Leicestershire County Council: North and East Melton Mowbray Distributor Road (MMDR)

Stage 2 Road Safety Audit

Report Number: 60542201-ACM-LSI-GEN_GEN_ZZ_Z-RP-CH-0002

30th November 2020

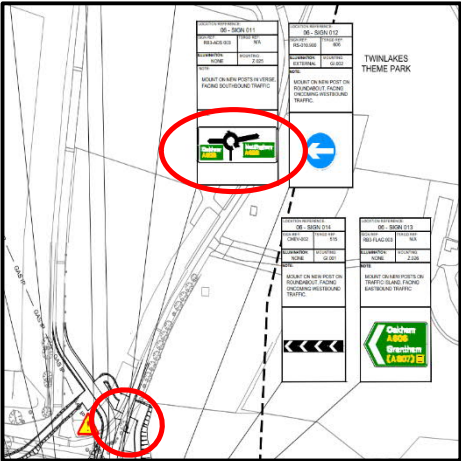
Problem 4.13.3	
Drawing Number(s):	60542201 ACM HSN S2_ML_ZZ_Z DR CH 0206 P01
Location:	Twin Lakes approach.
Summary:	Lack of keep left bollard on splitter island leading to kerb strikes and loss of control collisions.
Description:

A splitter island has been provided on the approach to Twin Lakes; however, a keep left bollard has been omitted from the design. If a keep left bollard is not installed an oncoming vehicle may travel too close to the splitter island and inadvertently strike it resulting in loss of control collisions.	
Recommendation:	
It is recommended that a keep left bollard is installed on the splitter island on the Twin Lakes approach.	
RSA 2 Designer's Response	
A keep left bollard will be installed on the splitter island.

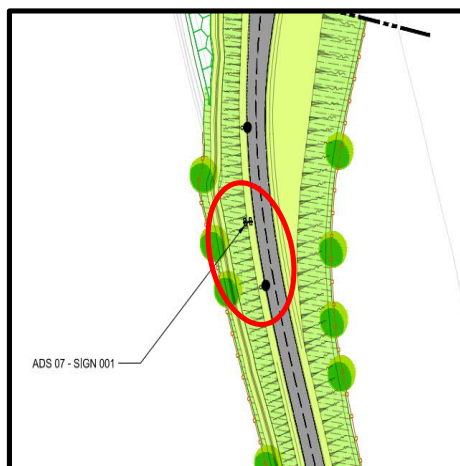
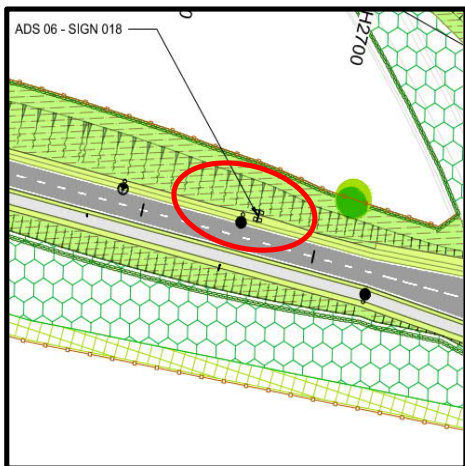
Problem 4.13.5	
Drawing Number(s):	Various.
Location:	Various.
Summary:	Proposed lighting columns located in close proximity to Advanced Direction Signs (ADS) leading to potential sign masking and sudden and sharp braking resulting in shunt-type collisions.
Description:

A number of proposed lighting columns have been detailed in close proximity to ADS, throughout the scheme extents (examples shown above). There is a risk that due to the close proximity of the lighting columns, some of the sign destinations may be masked to oncoming drivers. If drivers do not have clear sight of the signs, they may become hesitant or confused, on approach, leading to sudden or sharp braking and shunt-type collisions occurring.

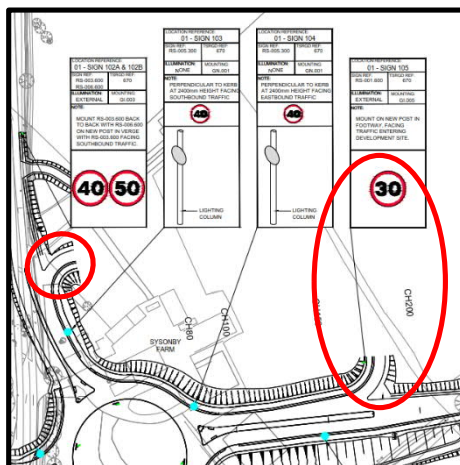
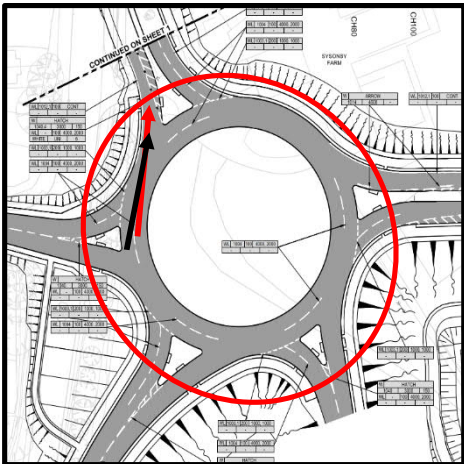
Problem 4.13.7	
Drawing Number(s):	60542201 ACM HSN S1_ML_ZZ_Z DR CH 0101 P01
Location:	Development site exit on to the A606 Nottingham Road.
Summary:	Lack of speed limit terminal sign resulting in inconsistent speeds and potential shunt-type collisions.
Description:

A 30mph speed limit terminal sign has been detailed at the access to the development site, east of Roundabout 1; however, no 40mph speed limit terminal sign has been detailed at the development site exit on to the A606 Nottingham Road. This could lead to inconsistent speeds as vehicles exiting the development site may travel at a lower speed than approaching southbound vehicles on the A606 Nottingham Road leading to potential shunt-type collisions.

It is recommended that a 40mph speed limit terminal sign is installed at the development site exit on to the A606 Nottingham Road.

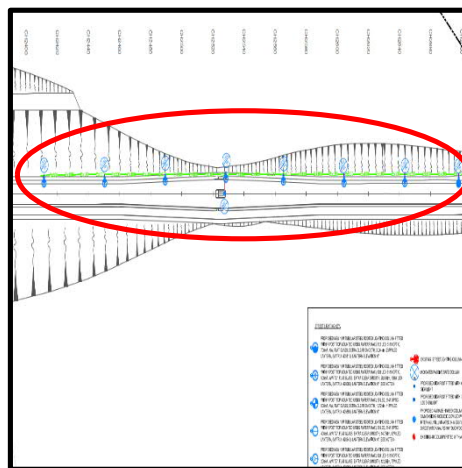
Problem 4.16.2	
Drawing Number(s):	Various.
Location:	Various locations throughout the scheme extents.
Summary:	Insufficient lighting provisions leading to dark patches within the footway or carriageway increasing the likelihood of personal injury collisions.
Description:

There are several locations throughout the scheme extents where the Audit Team feel there are insufficient lighting units to ensure that there is adequate luminance across the footway/cycleways and adjacent carriageways (a few examples are shown above). Of particular concern are the uncontrolled crossing facilities at the proposed roundabouts and sections of the shared footway/cycleway adjacent to the MMDR where no lighting is provided or only provided within the opposing verge. If the shared footway/cycleways and carriageways are not sufficiently lit, drivers may not see NMUs in the relative shadows and be unable to identify their intended movements. This could result in NMU injuries or collisions with hazards in the carriageway, leading to personal injury collisions.

The level of lighting provided will be checked to ensure that there are sufficient lighting levels for motorists and non-motorised users adjacent to the carriageway.

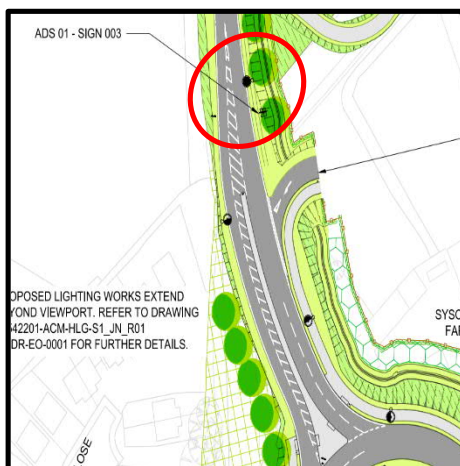
Problem 4.16.3	
Drawing Number(s):	Various.
Location:	Various locations throughout the scheme extents.
Summary:	Trees positioned too close to street lighting units increasing the likelihood of dark patches being present on the shared footway/cycleways and carriageways resulting in personal injury collisions.
Description:

Trees are proposed at various locations throughout the scheme extents, with several locations where the trees appear to be positioned close to a proposed lighting column (example shown above). If trees are positioned too close to a lighting column, when in full growth the branches may mask the lighting column unit, leading to dark patches being present on the adjacent shared footway/cycleway or carriageway. If dark patches are present, the likelihood of collisions occurring, or users striking a hazard on the shared footway/cycleways or carriageway will be heightened.
